The Department of Toxic Substances Control (DTSC) received the *Draft Phase IV Field Sampling Plan Addendum 1* (Addendum) for the University of California (UC), Berkeley, Richmond Bay Campus, Former Richmond Field Station Site, located in Richmond, California. The October 03, 2014 Addendum was prepared by Tetra Tech, Inc. and transmits to DTSC as an Attachment the September 30, 2014 document titled *Exploratory Excavation Work Plan, Exploratory Investigation for Magnetic Anomaly Source in Bulb* (Work Plan). The Work Plan, prepared by Cabrera Services Inc. for UC, is the subject of our review. Comments and recommendations based on our review are provided as attachments to this letter. Also attached are comments and recommendations on the Work Plan prepared by DTSC's industrial hygiene branch, and human and ecological risk branch.

Department of Toxic Substances Control Comments to 09/30/2014 UC Phase IV Work Plan, Addendum I

SUBJECT: UC Berkeley, Richmond Field Station
Richmond, California
Air Monitoring Plan; Health and Safety Plan Review
PCA Code: 11018 Site Number: 201605-00

Figure 102. Diagram of magnetic anomaly over burial trench. Note that the peak anomaly may not necessarily lie over the center of the trench due to the angle of the earth's field.

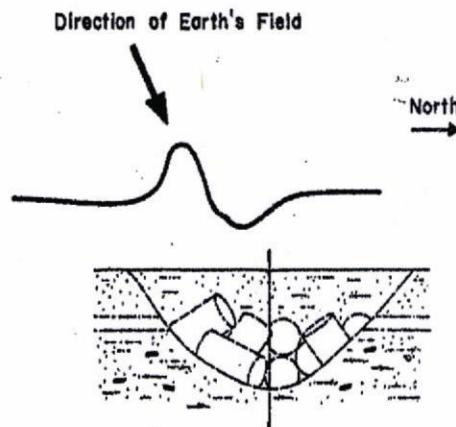
It is proposed in the plan that a single excavation should be completed, centered on the strongest magnetic anomaly. As illustrated below, the strongest anomaly measured by the magnetometer is not expected to be directly above the center of the metallic source but rather off-set to the south by some distance. Accordingly, the excavation must include the area north of the maximum anomaly. Figure 1, illustrating the anomaly and surrounding area, is attached for your reference.

Rather than opening a 10 ft by 10 ft excavation, we recommend excavating three trenches extending across the anomaly as identified by the highest magnetometer readings. The trenches should traverse the anomaly in directions roughly perpendicular to the northwest-southeast anomaly trend and extend beyond the illustrated anomaly farther to the north or northeasterly directions than to south or southwesterly directions. Each trench can be backfilled before starting the next trench minimizing the amount of open excavation and associated stockpiled materials. Recommended trench locations are illustrated on the attached Figure 2.
